Falling-edge and rising-edge overshoot specification refinement

Problem statement

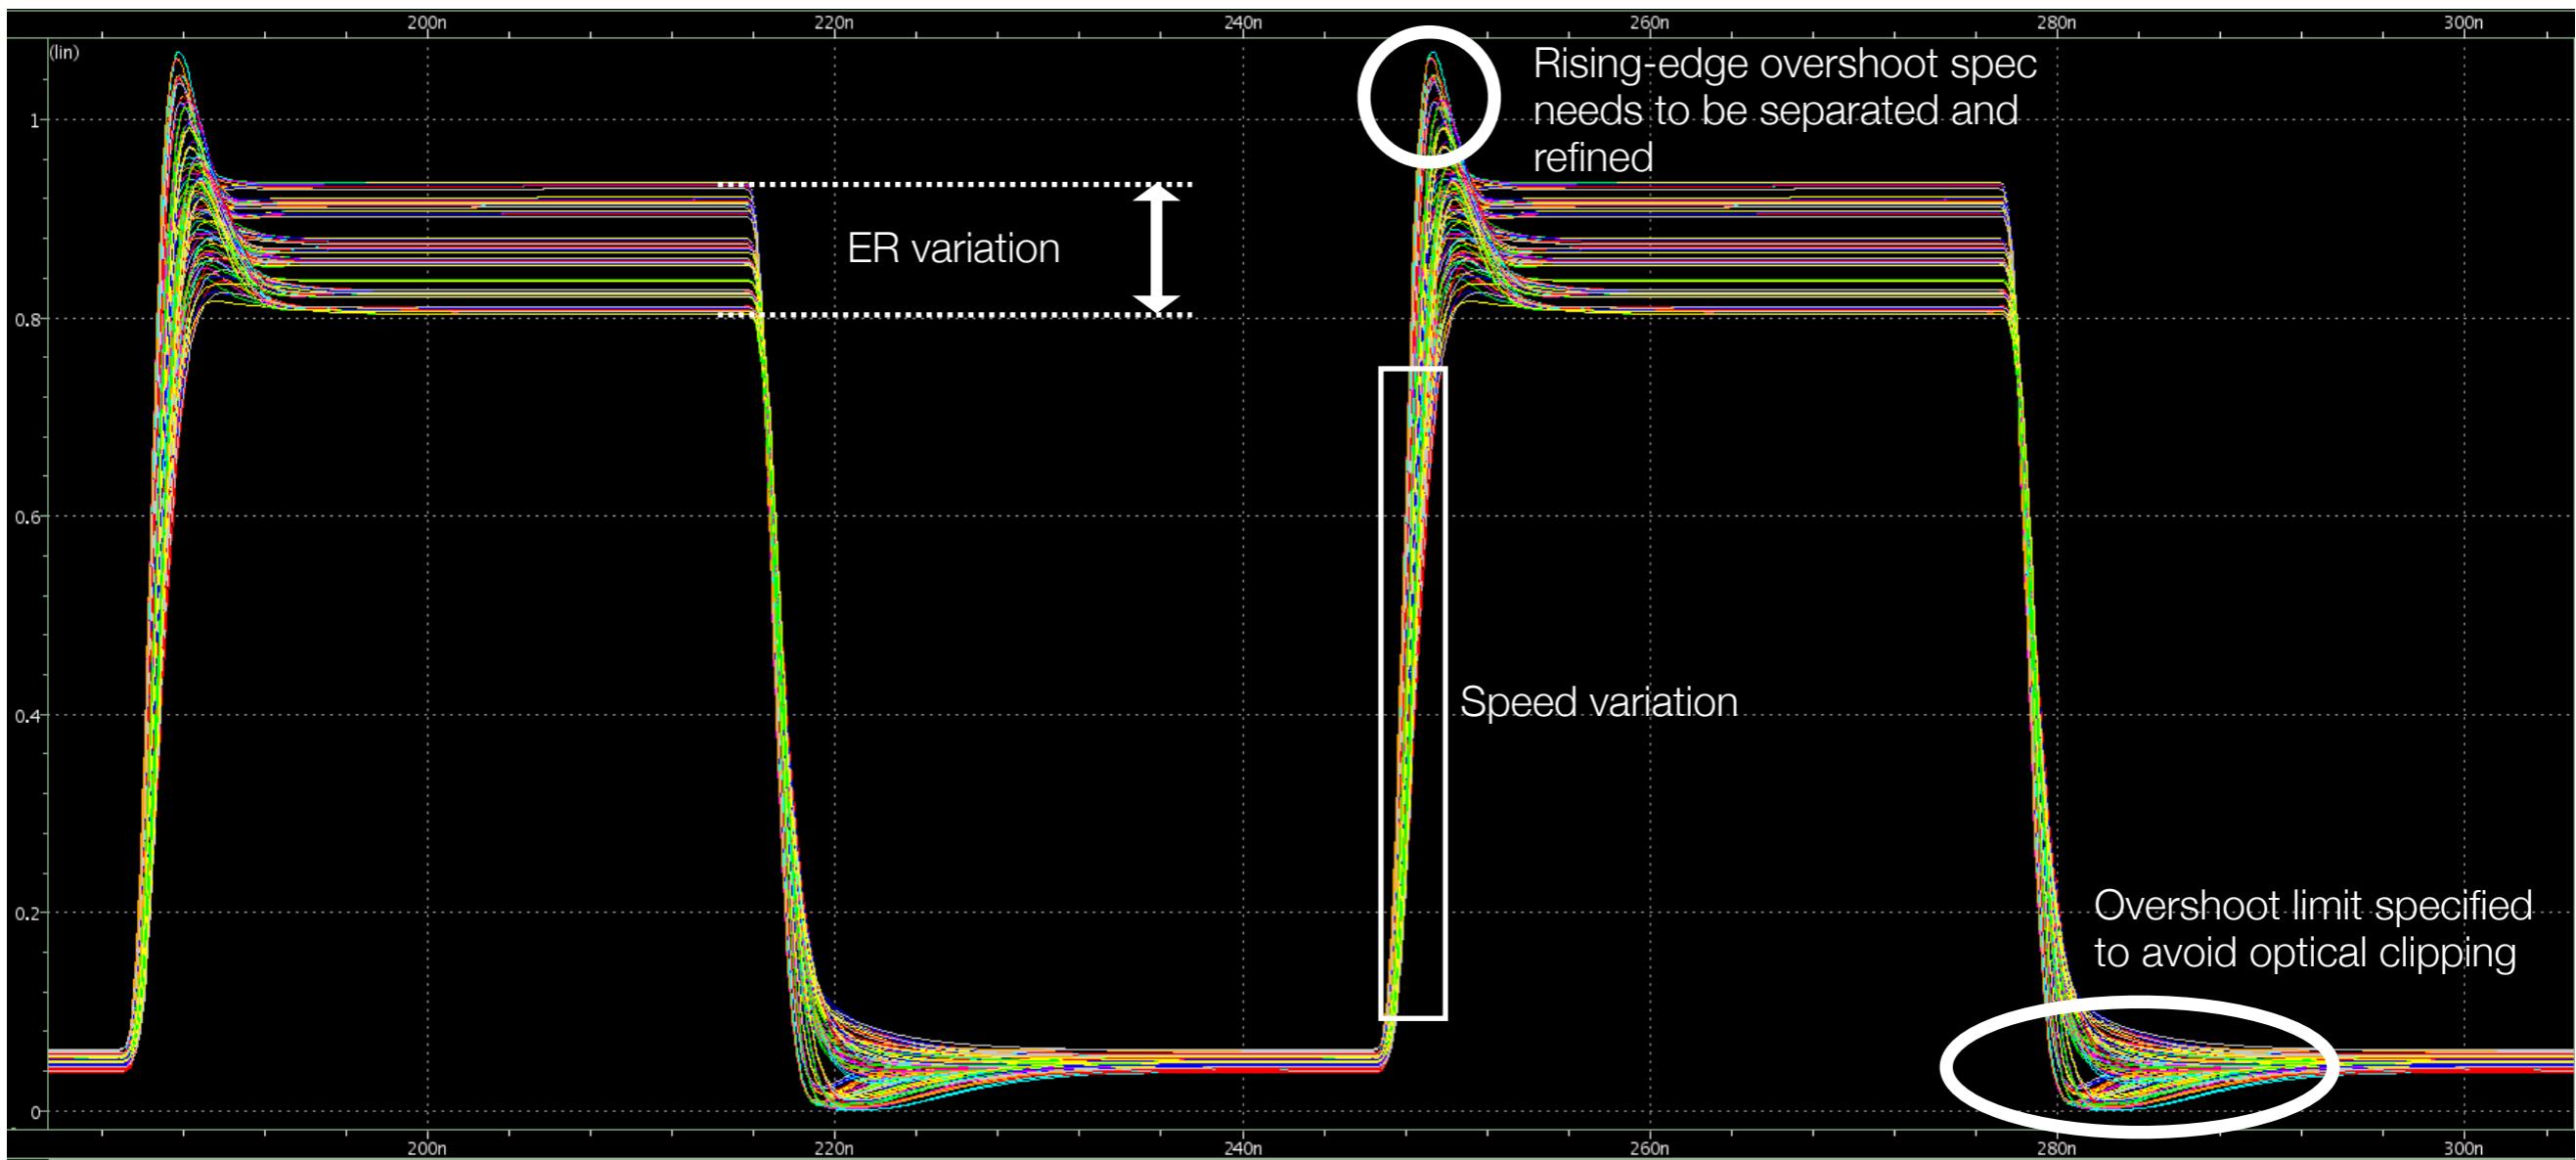
- Asymmetry between rise/fall times and rising/falling edge overshoot
- PMD TX signal at TP2 under test mode 3 generation in PVT variation for a specific design:
